Optimizing an Engineered Slope Conveyor System –
An OEM / Operator Collaboration

Preliminary Design Review

Figure 1. Preliminary Slope Design Layout Drawing

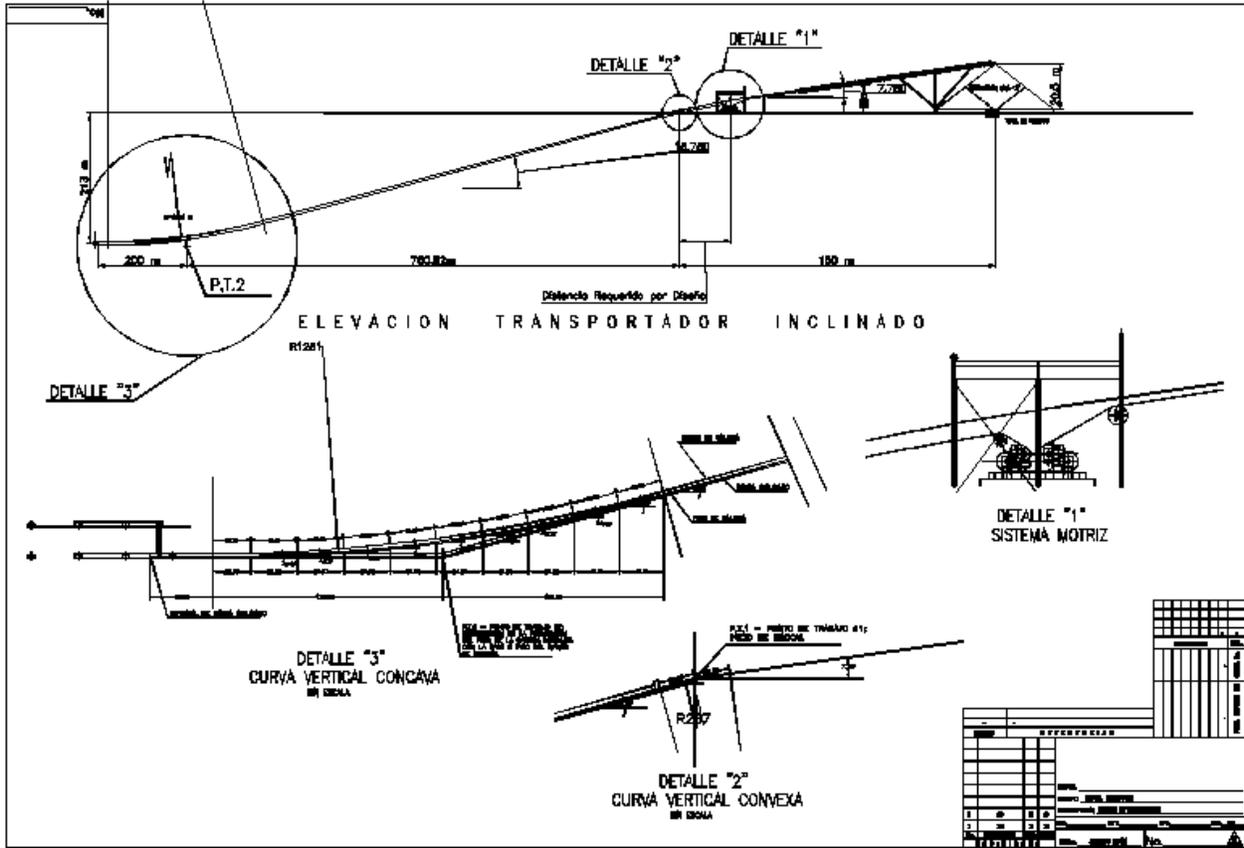
The preliminary design layout drawing provided (Figure 1) shows a slope conveyor that transports the run of mine (ROM) coal from underground and discharges the material directly onto the ground above a reclaim tunnel. The design includes a radius of curvature at the bottom of the slope to properly transition the conveyor from horizontal to an incline of 15.75°. This angle is maintained until reaching the surface. Immediately outby the portal is a four-pulley drive assembly, which includes two bend pulleys to properly transfer the belt into and out of the drive. Outby the drive assembly the incline is decreased to 7.78° which is maintained until reaching the discharge (or head) that is elevated 20.5 m above the ground. This portion of the conveyor will be supported by a truss structure. Also, on the return side of the slope conveyor, approximately halfway between the four-pulley drive assembly and discharge, there is a gravity take up assembly.

Once the general design specifications for the slope conveyor had been agreed upon, it was possible to discuss the details of this design. Caterpillar then presented their review of the preliminary slope layout drawing (Figure 1). The issues regarding the gravity take up located between the drive and discharge were discussed, and the operator quickly agreed that this would not be practical. However, the operator wanted to further discuss the possibility using a gravity take up located in by the drive. It was explained that even directly in by the drive, the counterweight would still be very large. The operator agreed that this also was not practical. Caterpillar then presented its recommendation to use a hydraulic cylinder take up located at the bottom of the slope near the tail. At this location the required take up tension would need to be 15,453 lbf. The operator agreed with this recommendation and decided to incorporate it into the design specification.

Figure 2. Initial Location for Gravity Take Up

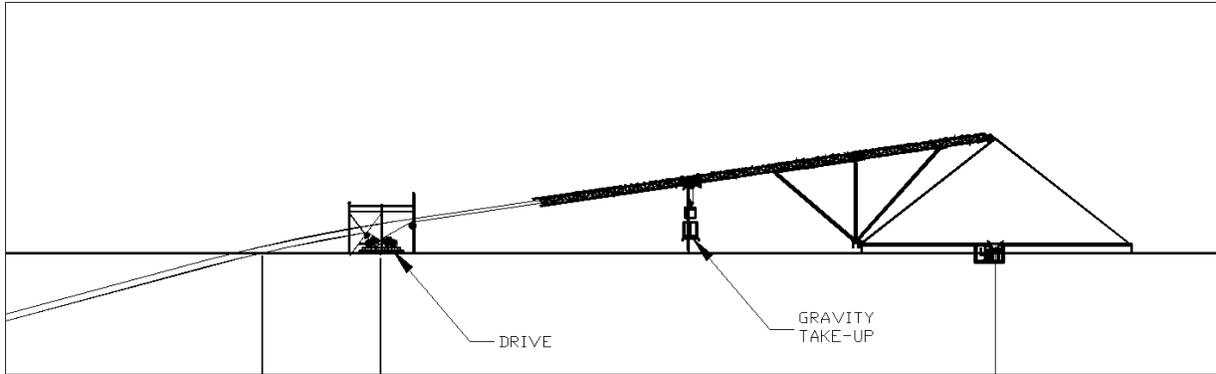
The first issue with this layout was the location of the gravity take up. As seen in Figure 2, the take up is located outby the drive assembly. In this location the required take up tension is close to the maximum tension seen throughout this slope conveyor. The highest tension is seen at the discharge (head) of the conveyor and locating the take up between the discharge and drive assembly is inadvisable and could be unsafe for the operator. For example, if the take up were placed in this location for Option 1 the counterweight would need to weigh almost 200 tons; obviously this is not practical. The only practical location for a gravity take up on the surface is inby the drive. This location allows for a more manageable counterweight; however there are some advantages and disadvantages to a gravity take up that will be discussed later.

Locating the take up at the bottom of the slope would greatly reduce the amount of tension required. From Table 2, a hydraulic cylinder take up located at the bottom of the slope requires a take up tension of 15,453 lbf. The data also show that a hydraulic take up located here has the advantage of allowing the operator to use ST4000 belting instead of ST4500, when compared to the gravity take up option. This is a significant cost savings that would offset the additional cost of the hydraulic take up versus the gravity take up. Another advantage is that a hydraulic take up has better response control when the operating conditions of the conveyor changes. This will reduce wear and tear on the belting during the day-to-day operation of the conveyor.

Figure 3. Preliminary Design Drive Arrangement

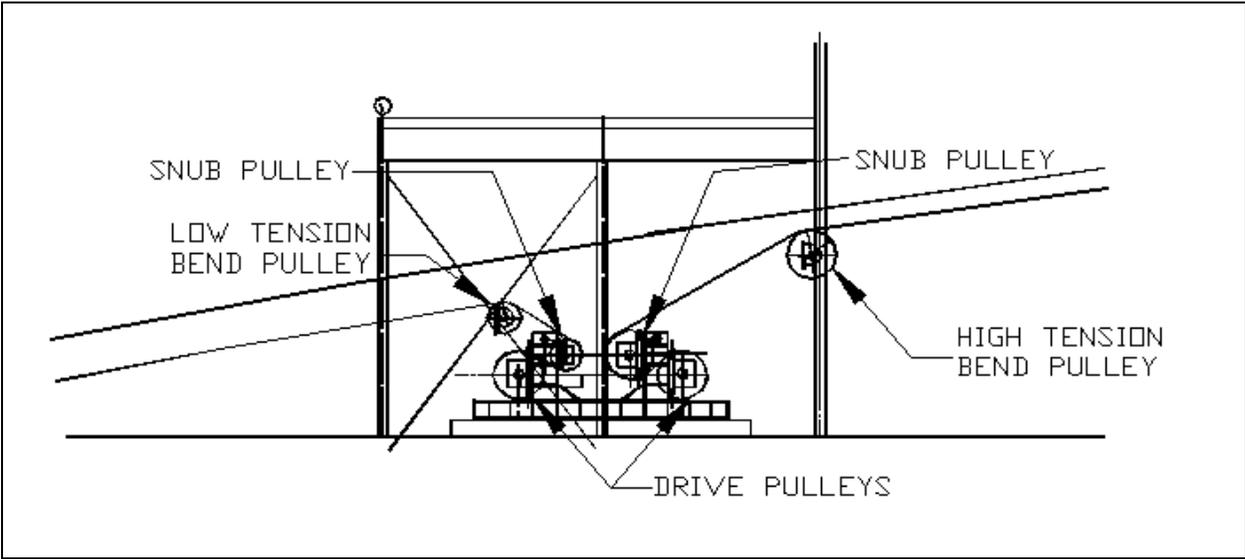
The next issue is a design weakness from an economic standpoint more than an operating concern. The preliminary design layout shown in Figure 3 is a four pulley drive assembly located on the surface underneath a truss frame structure. To properly transfer the belt in and out of the drive requires two bend pulleys, one inby and one outby the drive assembly. The bend pulleys are shown attached to the truss structure, which proved to be the primary reason for this structure. Also, the bend pulley located directly outby the drive will need to be a high-tension pulley.

From a design standpoint this drive layout appears to be appropriate, and in fact many slope conveyors use this very design. The primary reason for a four pulley drive arrangement is that it allows less belt slippage due to driving only on the clean side of the belt. However, if the belt is properly maintained with belt cleaners, this design becomes redundant, and unfortunately adds undue capital cost for the operator. The alternative to this design is a two pulley drive assembly layout. Moving the drive assembly closer to the portal of the slope eliminates the need for the high tension bend pulley. This two pulley design will be discussed in further detail later.

Figure 4. Belt Analyst Output for Option 1

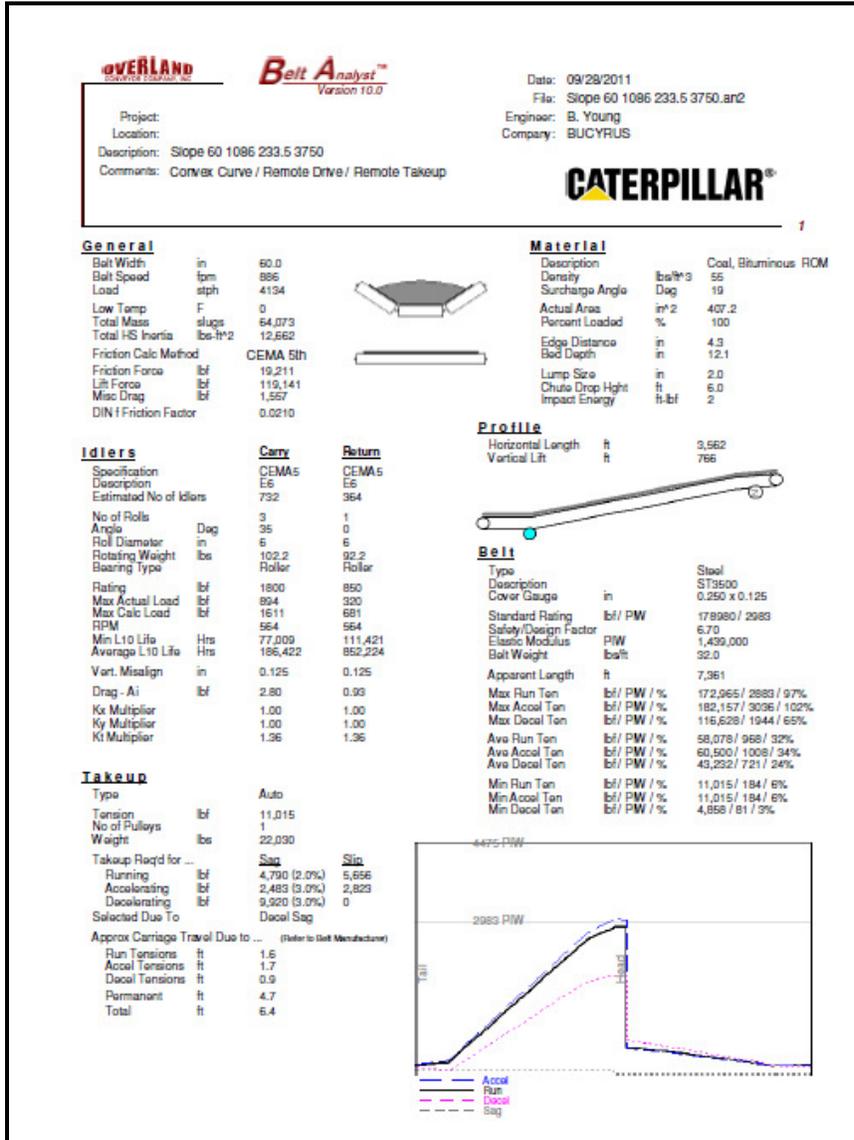
Since Option 1 is a 60” belt width design, it first had to be determined if this is a viable option at 5,500 mtph. Using Belt Analyst™ software by Overland Conveyor Company Inc., Caterpillar determined that the maximum capacity for this option is 3,750 mtph (4,134 stph) at 4.5 mps (886 fpm) (Figure 4). Therefore this option was eliminated based on capacity constraints.

Figure 5. Belt Analyst Output for Option 2

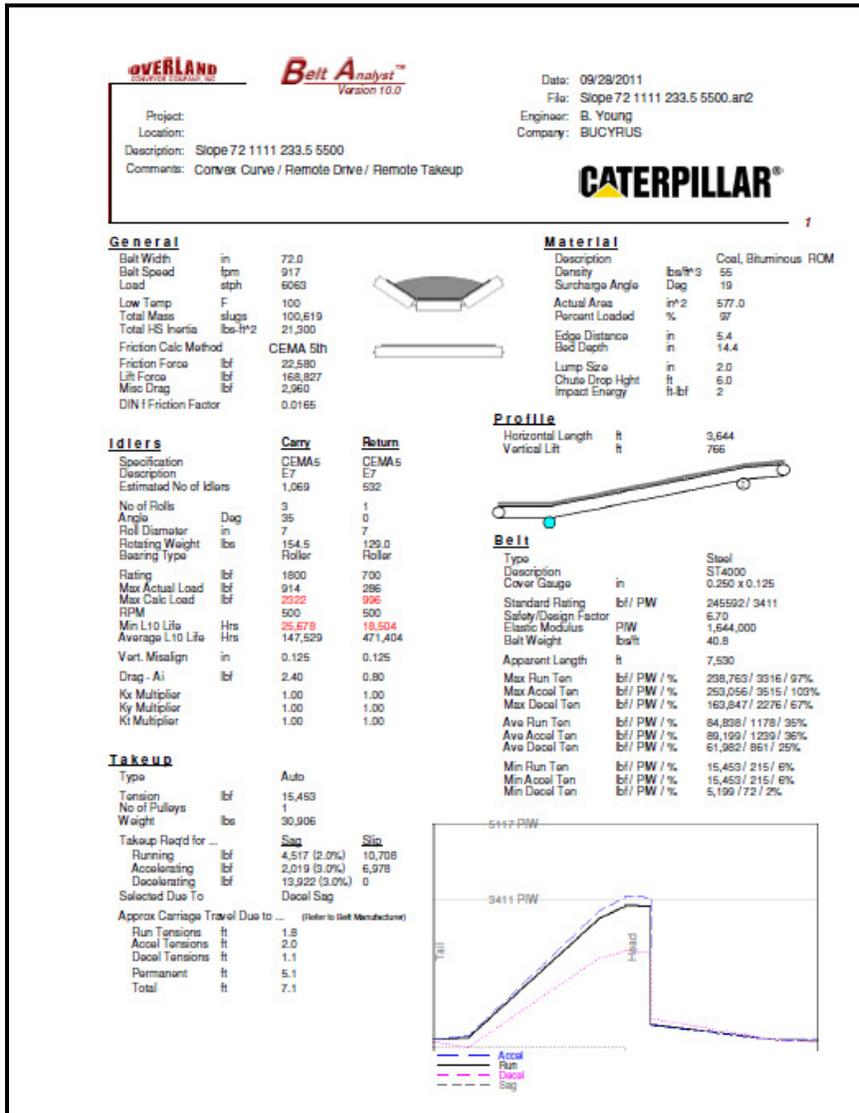
The design specification for Option 2 is a 72” belt width with a capacity of 5,500 mtp (6,063 stph) at 4.5 mps (917 fpm). From Figure 5, the Belt Analyst™ summary shows that this option is capable of running 5,500mtp based on a 97% volumetric load capacity. Option 2 requires a total of 6,400 hp and a take up that can apply 15,453 lbf belt tension (or 30,906 lbf counterweight), when placed at the bottom of the slope near the tail. The belting requirement is a steel cable ST4000 belting that has a rating of 3,411 PIW. The overall horizontal length of this conveyor is 1,111m (3,644 ft) which includes a vertical curve with a 1,251 m (4,104 ft) radius at the bottom of the slope.

Figure 6. Belt Analyst Output for Option 3

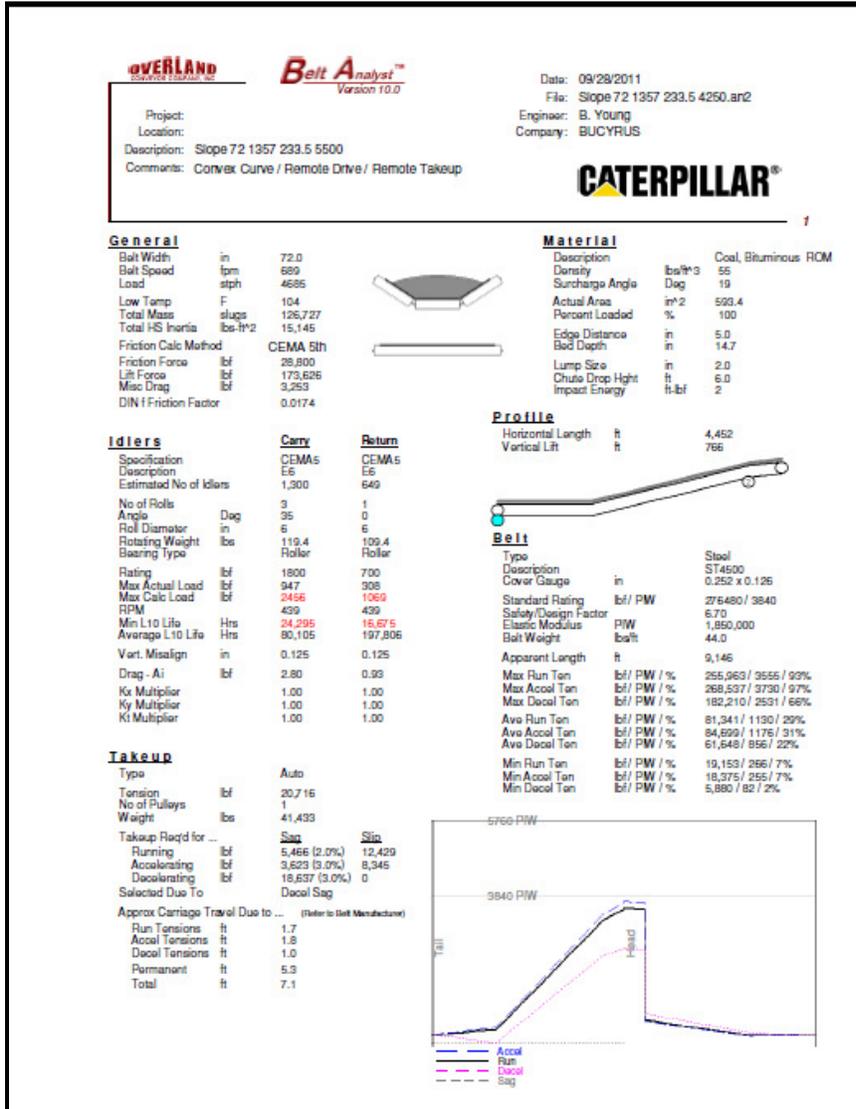
The design specification for Option 3 is a 72” belt width with a capacity of 5,500 mtp (6,063 stph) and a speed of 3.5 mps (689 fpm). From Figure 6, the Belt Analyst™ summary shows that at a belt speed of 3.5 mps, the maximum capacity is 4,250 mtp (4,685 stph). Therefore, this was deemed not to be a viable option.

Figure 7. Caterpillar Proposed Two Pulley Drive Layout

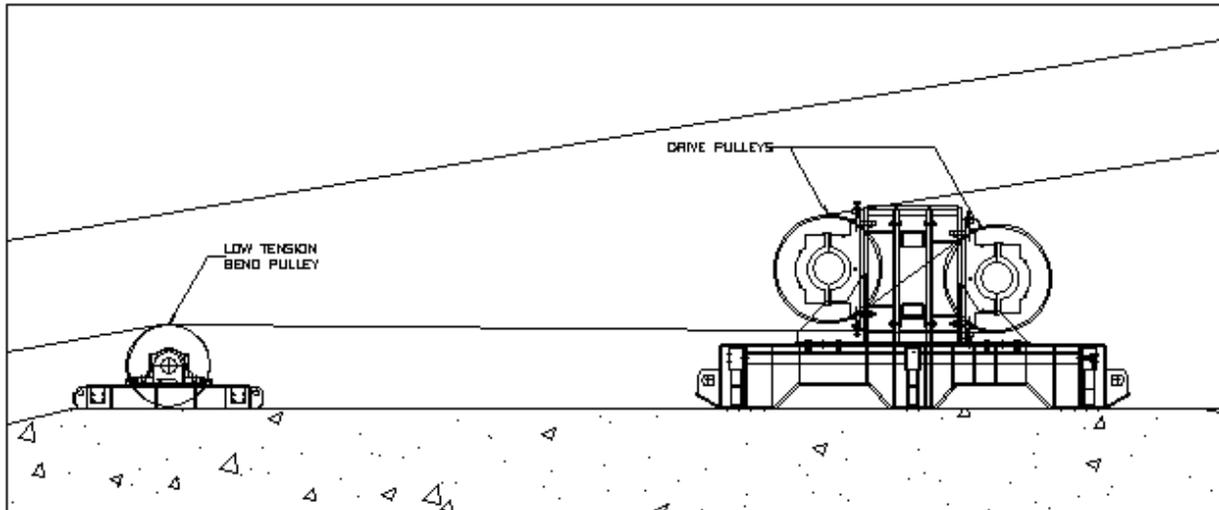
The next design consideration is the type of drive assembly for the slope conveyor. In the preliminary design, the EPCM proposed a four pulley drive arrangement. As stated earlier, a four pulley drive arrangement has been a common design for a slope conveyor, and the primary reason for this design is that it allows less belt slippage due to driving only on the clean side of the belt. However, as mine operations become more aware of the benefits of preventative maintenance programs, the focus has shifted to properly maintaining the belt using belt cleaners, thus it has become unnecessary to drive only the clean side of the belt. The alternative to this design is a two pulley drive assembly layout. A two pulley drive is the more economical design because it uses two fewer drive pulleys, as well as a much smaller drive frame. Another benefit of the two pulley design is the ability to move the drive assembly closer to the portal of the slope thereby eliminating the need for a high tension bend pulley. In a four pulley design a high tension bend pulley is required to properly transfer the belt into the drive from the head. As shown in Figure 7, a two pulley drive design located near the portal allows for proper belt transfer into the drive while maintaining the required 210° of belt wrap on the drive pulleys. While a low tension bend pulley is still required inby the drive to transfer the belt down the 15.75° slope, being able to eliminate the more expensive high tension bend pulley is another economic advantage for the operator.

Next, Caterpillar presented its recommendation to use a two pulley drive versus the four pulley drive. Also, it was shown that locating the drive closer to the portal would eliminate the need for a high tension bend pulley (Figure 7). The operator understood the lower cost of a two pulley drive; however they were concerned that this design would be prone to belt slippage. Caterpillar then showed several examples where a two pulley slope drive has been successful. Also with the proper use of belt cleaners at the head, as well as ceramic lagging on the drive pulleys, belt slippage was less of a concern. The operator was convinced that a two pulley drive was viable and decided to go with this design. They also agreed that placing the drive closer to the portal was the most optimum location and had the added advantage of eliminating the high tension bend pulley.
